LARAMIE COUNTY PLANNING & DEVELOPMENT DEPARTMENT

MEMORANDUM

TITLE: PUBLIC HEARING regarding a Revised Commercial Site Plan for the Horse Creek Rock Quarry Expansion, located in a portion of land being situated in the E ½ Section 31, Section 32, T18N, R70W, and Section 5 and 6, T17N, R70W, Laramie County, WY.

REVISED COMMERCIAL SITE PLAN
HORSE CREEK ROCK QUARRY
EXPANSION

There will be no public maintenance of the internal roadway/access easements

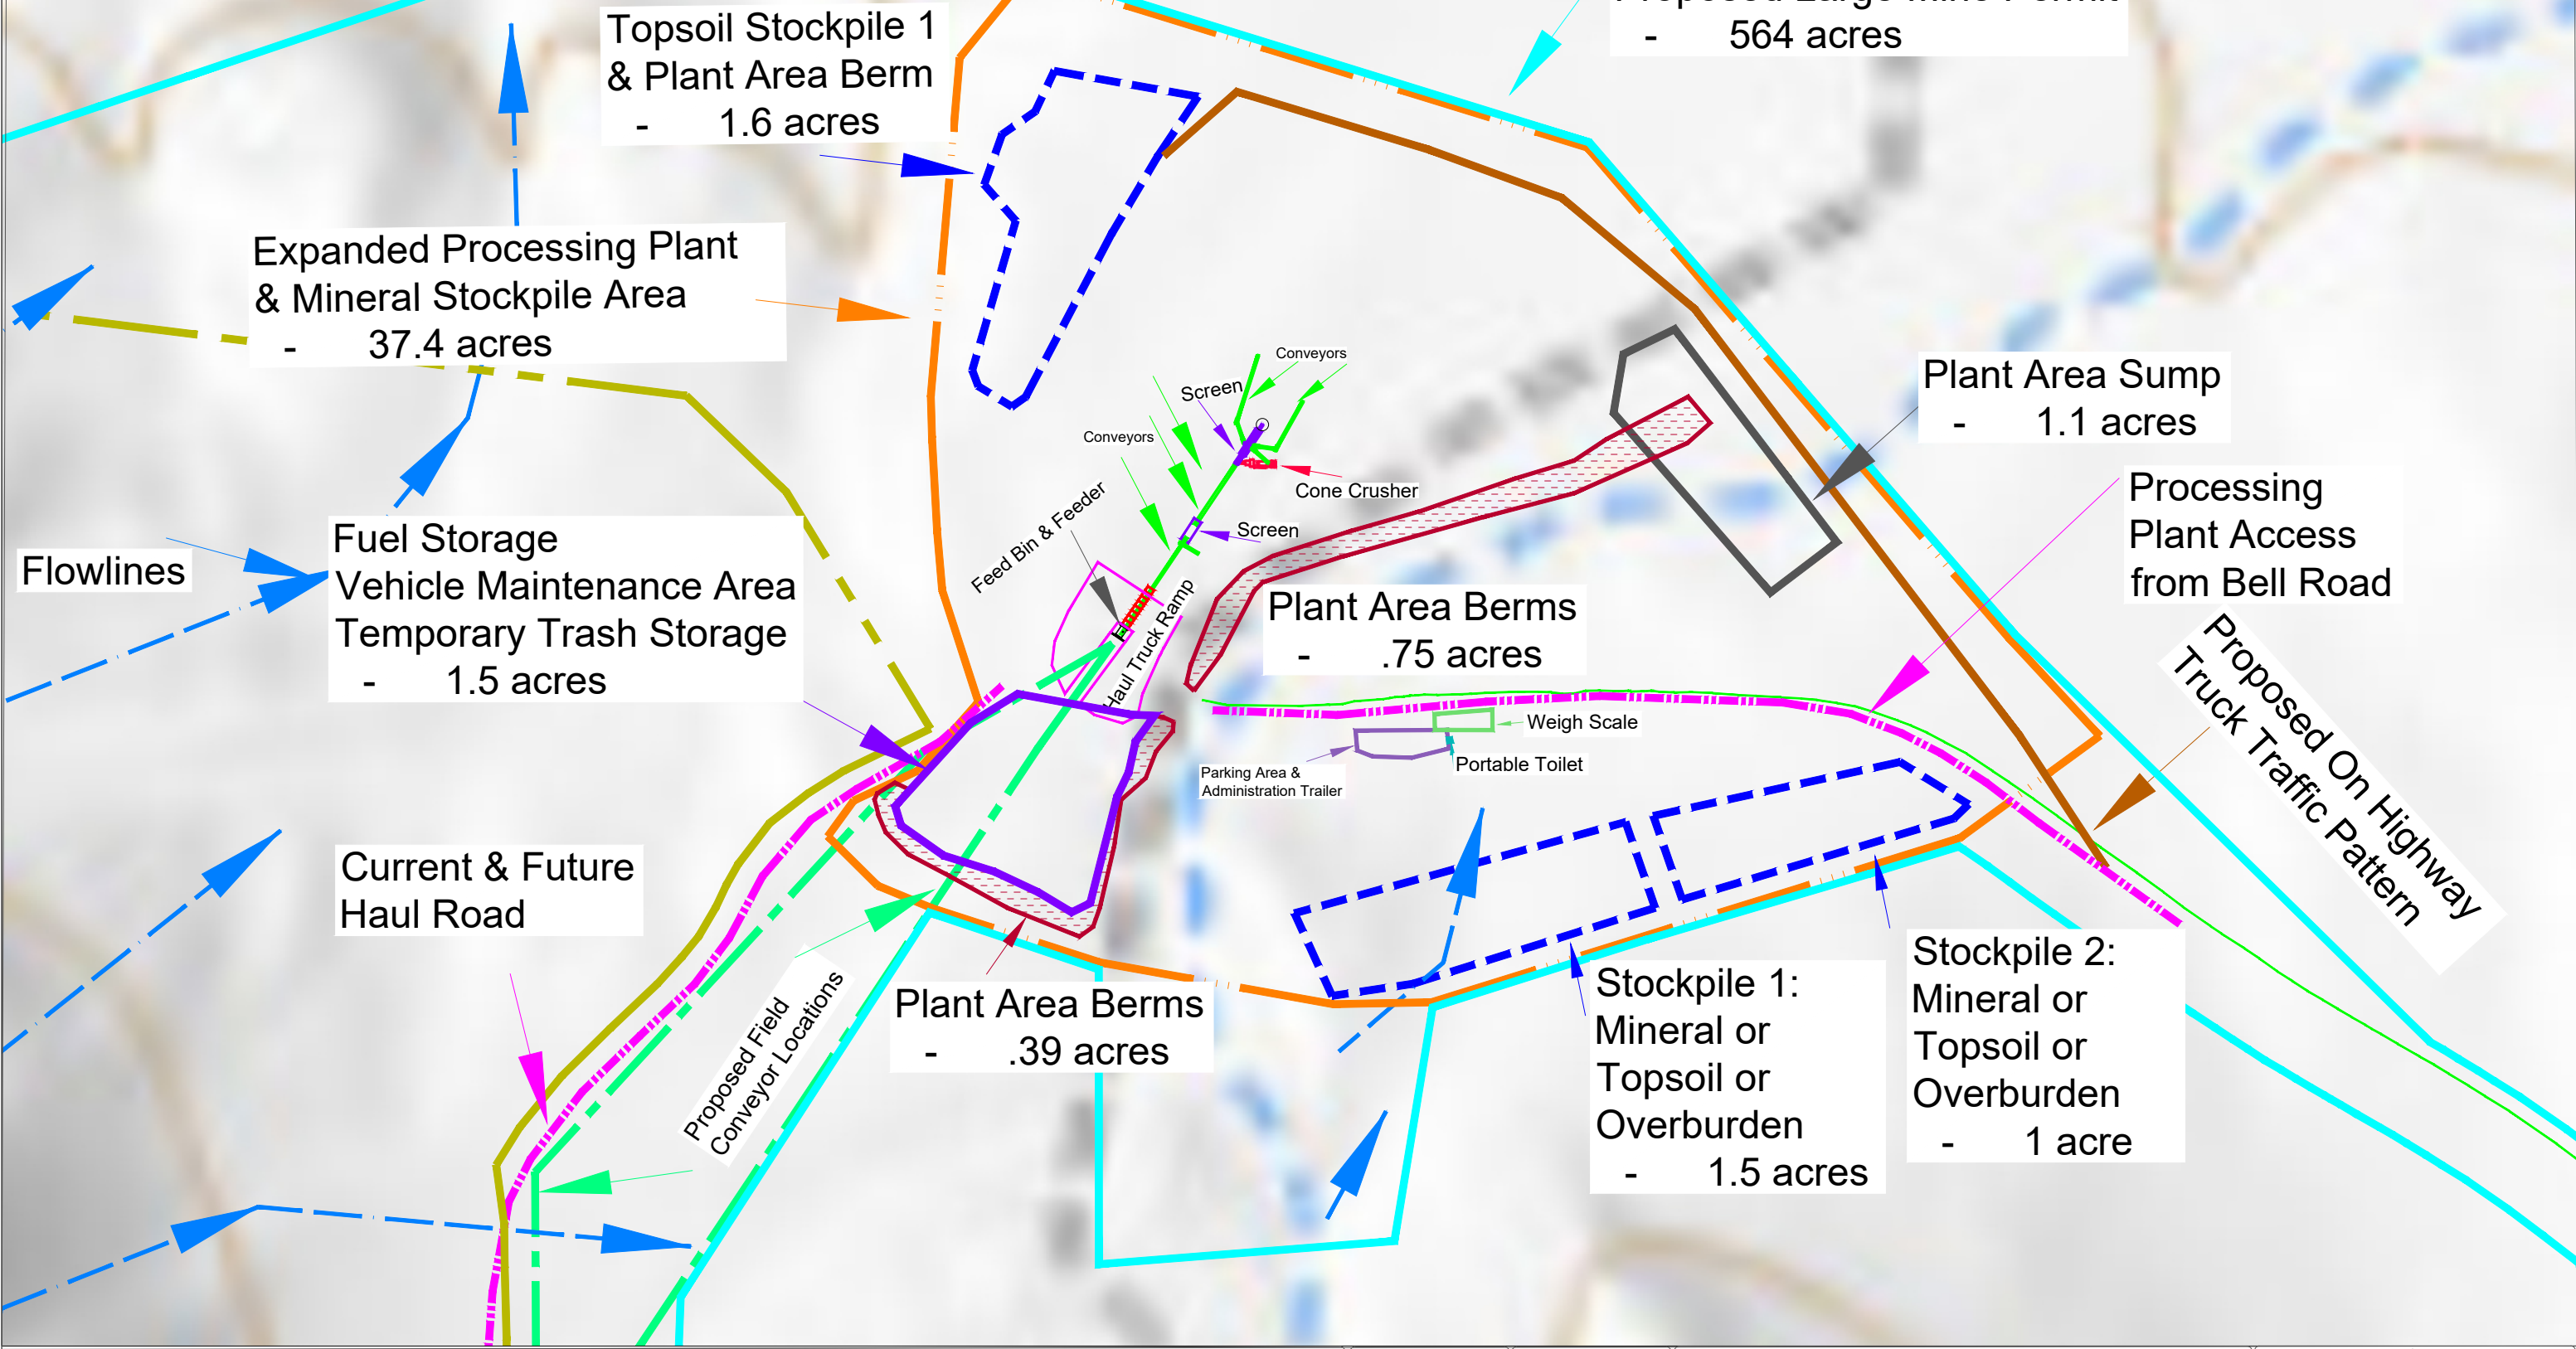
05/11/2026	05/11/2026	Workflow	BUILDING FIRE DEFICIENCY CODE REVIEW	NO DIMENSIONS PROVIDED FOR REVIEW. Premises identification shall be in accordance with 2024 IFC section 505 and 2024 IRC section 308, and 2024 IBC section 502.1. Fire Apparatus Roads required per 2024 IFC section 503. Fire protection water Supplies required per 2024 IFC section 507	DANIEL.PETERS@LARAMIECOUNTY.WY.GOV
<p>Attached to this document is a detailed site plan map for the project site's 3 structures, all of which are located in the Plant Site area of the project. Those 3 structures are: 1) Administration Trailer, 2) Weigh Scale, and 3) Storage Building/Quality Control Lab. Dimensions of each structure and the structures' distance from the site access road are provided on the map.</p>					
05/12/2026	05/12/2026	Application	PZ-26-00042 GENERAL	Ensure that all access and egress roads allow for emergency services	MATTHEW.BUTLER@LARAMIECOUNTY.WY.GOV

<p>LGE acknowledges this requirement: that a review of traffic and CMV weights will be reevaluated every 5 years or when a new sherriff administration is sworn in.</p>					
05/18/2026		Workflow	ENVIRONMENTAL HEALTH REVIEW GENERAL	Plan is to use porta potties and licensed pumper.	TIFFANY.GAERTNER@LARAMIECOUNTY.WY.GOV
05/18/2026		Workflow	ENVIRONMENTAL HEALTH REVIEW GENERAL	Plan is to use porta potties and licensed pumper.	TIFFANY.GAERTNER@LARAMIECOUNTY.WY.GOV
05/18/2026		Workflow	PUBLIC WORKS REVIEW GENERAL	1. At time of review by Public Works, the review engineer comments had not been submitted. If the comments need further conversation and/or clarification, please do not hesitate to reach out to Public Works. 2. All comments from the review engineer shall be addressed. 3. Any internal roadways on the site shall comply with the needs of emergency services. 4. Any work taking place within the boundaries of the designated floodplain and/or floodway will require an approved Floodplain Development Permit through the Laramie County Planning and Development office. 5. A note shall be added to the site plan indicating "there will be no public maintenance of internal roadways/access easements."	MOLLY.BENNETT@LARAMIECOUNTY.WY.GOV

<p>05/18/2026</p> <p>Workflow</p> <p>PUBLIC WORKS GENERAL REVIEW</p> <p>The existing access road at the Horse Creek site was constructed in adherence with the WYDOT access permit LA-07A-48569 (attached). All roads at the site are 20' wide to accommodate emergency services.</p> <p>No work is planned to occur in a flood plain at the Horse Creek Rock Quarry; as there are no flood plains present in the permit area. A flood plain map was provided in the Conditional Use Permit application for this operation, a copy of which is provided as an attachment to this document.</p> <p>The following phrase has been added to the Site Plan: "There will be no public maintenance of the internal roadway/access easements."</p>		<ol style="list-style-type: none"> 1. At time of review by Public Works, the review engineer comments had not been submitted. If the comments need further conversation and/or clarification, please do not hesitate to reach out to Public Works. 2. All comments from the review engineer shall be addressed. 3. Any internal roadways on the site shall comply with the needs of emergency services. 4. Any work taking place within the boundaries of the designated floodplain and/or floodway will require an approved Floodplain Development Permit through the Laramie County Planning and Development office. 5. A note shall be added to the site plan indicating "there will be no public maintenance of internal roadways/access easements." 	<p>MOLLY.BENNETT @LARAMIECOUNT YWY.GOV</p>

<p>The existing access road at the Horse Creek site was constructed in adherence with the WYDOT access permit LA-07A-48569 (attached). All roads at the site are 20' wide or greater to accommodate emergency service vehicles.</p> <p>No work is planned to occur in a flood plain at the Horse Creek Rock Quarry; as there are no flood plains present in the permit area. A flood plain map was provided in the Conditional Use Permit application for this operation, a copy of which is provided as an attachment to this document.</p> <p>The following phrase has been added to the Site Plan: "There will be no public maintenance of the internal roadway/access easements."</p>

The following phrase has been added to all of the maps associated with LGE's Site Plan application:

The updated Site Plan map packet (which includes the above phrase on all the maps) is provided at the end of this submittal; i.e. the last 6 pages of this PDF document.

There will be no public maintenance of the internal roadway/access easements.
